Proposed Technical Specification Change

Reference is made to Pilgrim Station Operating License No. DPR-35, Sections 2.1.A1.a, 2.1.B, 2.1.1, Bases for 2.1.A, Figure 2.1.3, Table 3.2.C, and Figure 3.11-9. The following pages are affected: 6, 7, 8, 9, 15, 21, 54, and 205H.

Figure 2.1.1

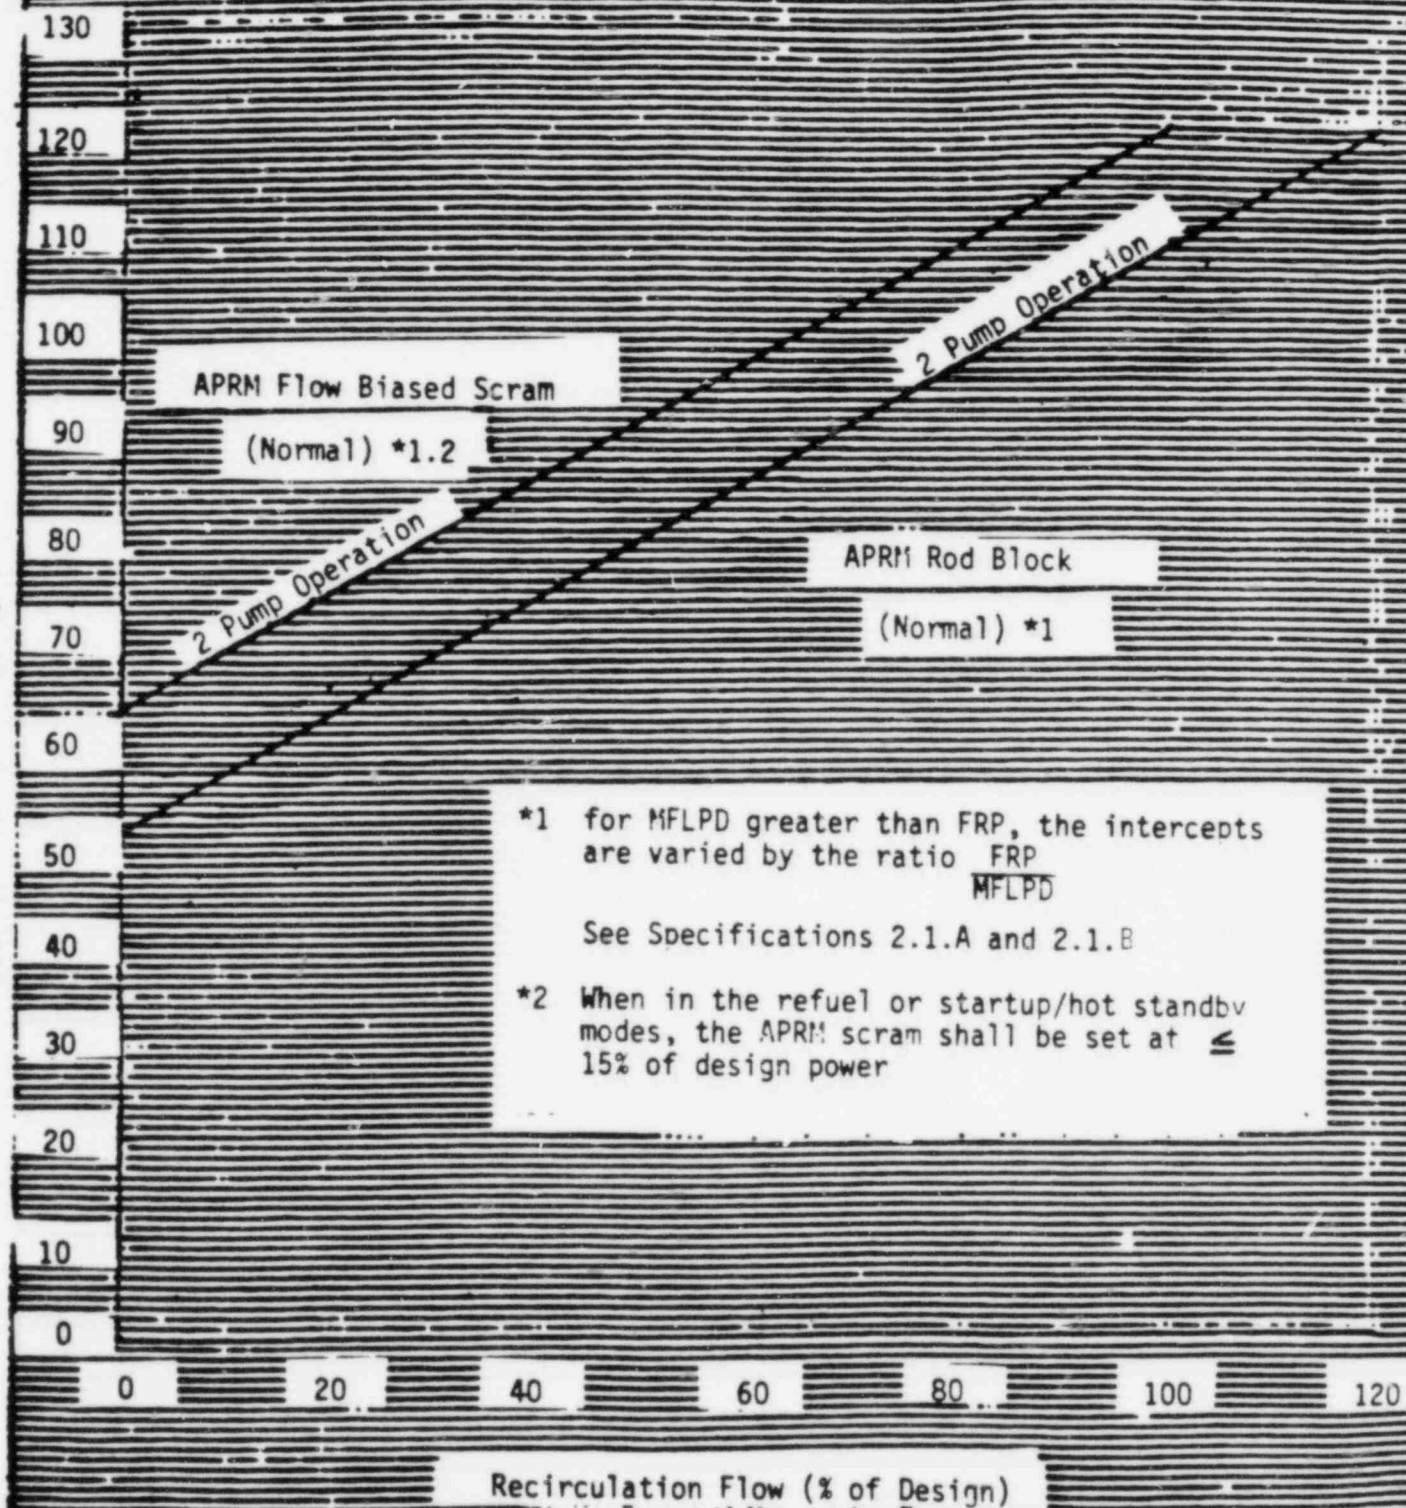
Figure 2.1.1 is to be replaced with the revised 2.1.1 attached to this submittal.

This submittal expands the operating region of Pilgrim's power/flow map, and provides associated changes in the APRM flux scram and APRM rod block trip settings.

$$S \leq .58W + 62\% \text{ 2 loop}$$

$$S_{RB} \leq 0.58W + 50\% \quad \underline{2 \text{ Loop}}$$
